**CONTRA COSTA  
WATER DISTRICT**

July 19, 2012

**Subject: Bay-Delta Conservation Plan Impacts to Contra Costa Water District and its Customers**

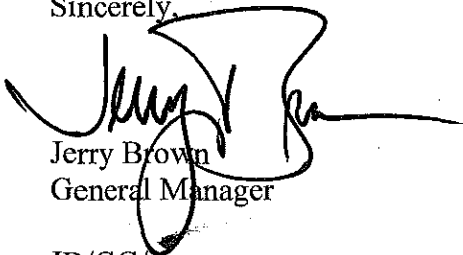
***The BDCP preliminary draft EIR/EIS fails to disclose, discuss or propose mitigation for these impacts to CCWD.***

These impacts to CCWD are not fully revealed in the preliminary draft EIR/EIS, nor are any mitigation measures proposed that would reduce impacts to CCWD. While the analytical tools used were designed to calculate impacts to CCWD, and the results clearly show them, the preliminary draft EIR/EIS does not disclose at all the extent of these impacts to CCWD operations and Los Vaqueros Reservoir water reliability and water quality. Given that these impacts on CCWD's system, operations and customers are so large, there is no reasonable explanation for the failure to disclose the impacts in the draft EIR/EIS or to identify mitigation for these impacts.

You now have the opportunity to direct the BDCP to make the necessary corrections, fully disclose impacts to CCWD and provide full mitigation for those impacts. CCWD urges you to redirect the BDCP efforts to design a plan that 1) avoids impacts where possible, 2) mitigates all impacts that cannot be avoided, and 3) fully discloses the policies, operations, impacts and mitigation of the BDCP prior to releasing the draft EIR/EIS.
